**Re: Rapiscan AIT System Radiation Survey Reporting**

FORM R-0646-1  
(Single Pose)

## R-0646-1 Addendum (Documentation Errors)

#### 1. In Beam Dose Measurement: Survey Table. 1

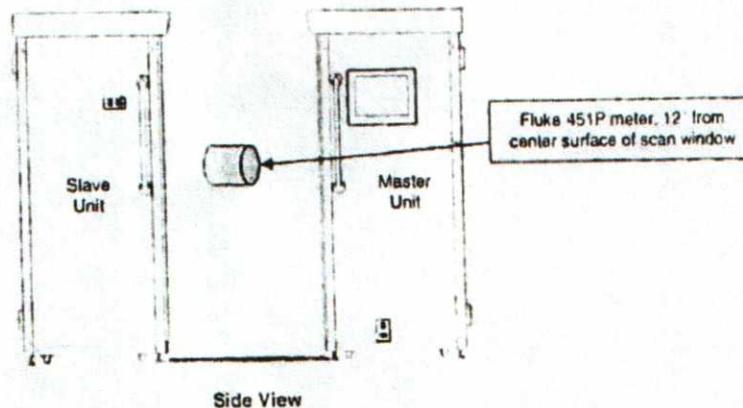
1. No value indicated for background radiation. Typical values range from 7uRem/hr to 13uRem/hr at sea level. Note: Absence of value has no adverse impact on calculations.
2. Technician indicated scan time as 7 seconds. Correct scan time is 3 seconds.
3. TABLE 1: Incorrect presentation of data in Column 3 for Measured Exposure. Indicated values are 29uR and 36uR. Corrected values are 2.9uR and 3.6uR. The values were corrected by technician when calculating Effective Dose.
4. TABLES 2 and 3: Incorrect presentation of data in Column 6 for Dose Equivalent. Indicated values are .18 uRem. The correct value should be 1.8 uRem.

The service technician should attend refresher training.
